Coastal Access Modification Report MR1

Proposed changes to the submitted England Coast Path proposals for Anglian Water Sewage Works to Mersea Stone, Mersea Island

Location affected: Mersea Outdoors to Coopers Beach Holiday Park, Mersea Island

Natural England's Modification Report to the Secretary of State

Map MR1b - Mersea Outdoors to Coopers Beach Holiday Park

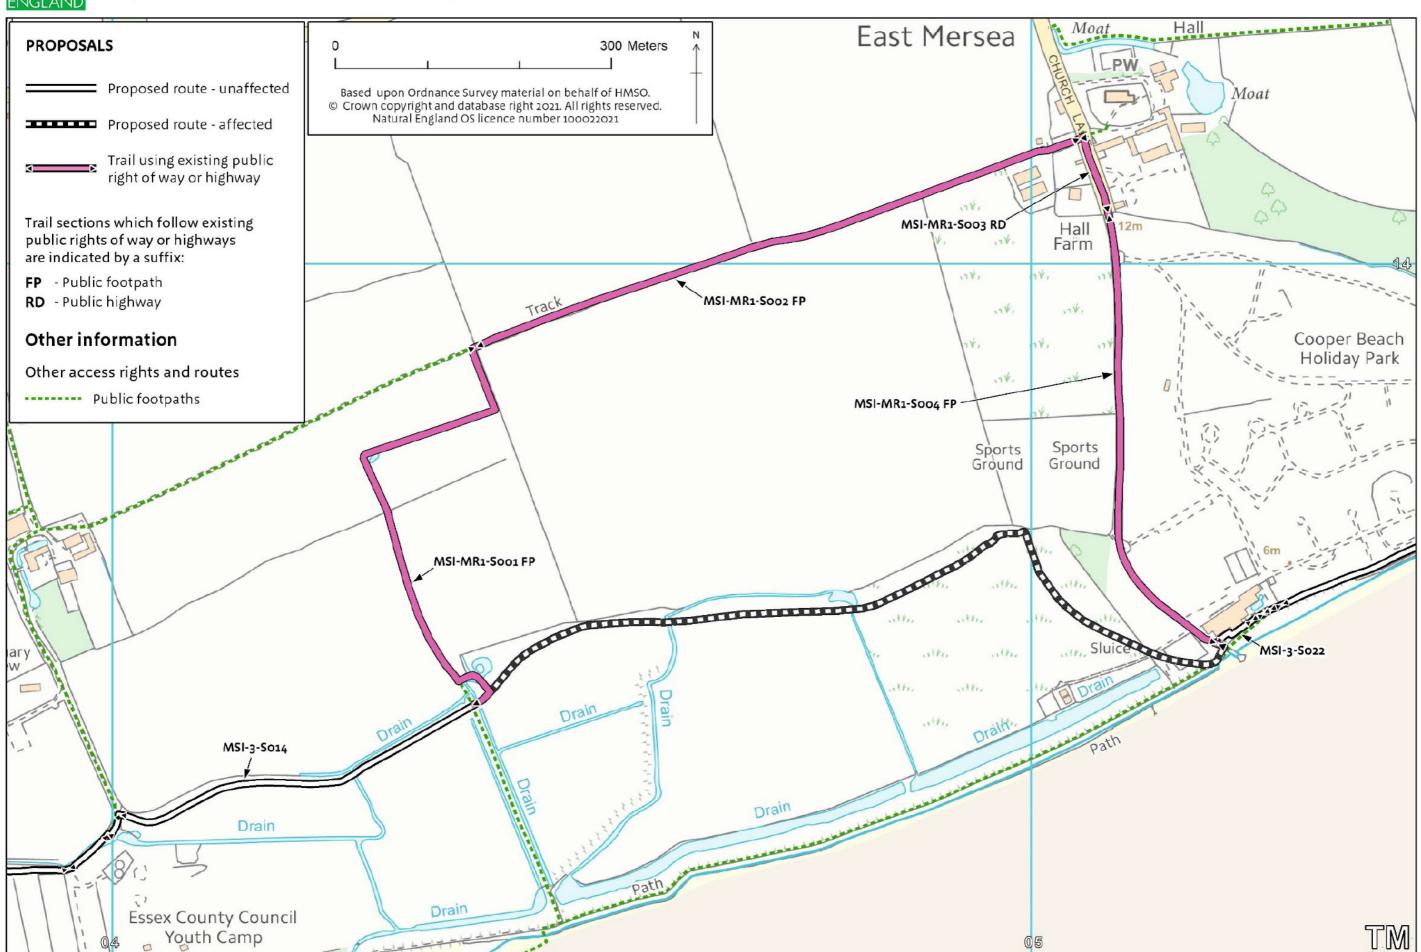
- 2.2.1 Our proposal (see map MR1b) is, from east to west, to re-route the path shown as part MSI-3-S014 (part of) to MSI-3-S021FP in our original report.
- 2.2.2 The modified proposed route is to take the existing public footpath from grid reference SS6043 2135 (MSI-MR1-S001FP) in a northerly direction to join the public footpath (MSI-MR1-S002FP) that goes eastwards to join Church Lane (MSI-MR1-S003RD). From Church Lane the proposed modification is to go southwards down Church Lane and along the public footpath (MSI-MR1-S004FP) along the access road to Cooper Beach Holiday Park, re-joining the original trail alignment at grid reference SS6051 2135 (MSI-3-S021FP).
- 2.2.3 The length of the modified proposed route is 1850m compared to the original proposal of 965m.

- 2.2.6 The modified proposal is to align this section of path further up the slope on existing public rights of way.
- 2.2.7 A benefit of the new proposal is that it avoids the need to install the new bridges within the saltmarsh and also avoids any disturbance on what would have been a new route. Since the proposals were published in June 2017, the erosion of the seawall (effectively 'unmanaged realignment' of the coast) has led to the inundation of a significant area, which is likely in time to attract wildlife interest. As this habitat was not present in 2017, it was not assessed in the published Mersea Island sensitive features report.

- 2.2.15 Column 4 of table 2.3.1 proposes that the modified section of trail should be able to roll back in this way, as the previously proposed alignment would have been able to. In relation to the modified route section MSI-MR1-S001FP to MS1-MR1-S004 FP, the route, as initially determined at the time this report is prepared, is to be at the centre of the line shown on map MR1b as the proposed route of the trail.
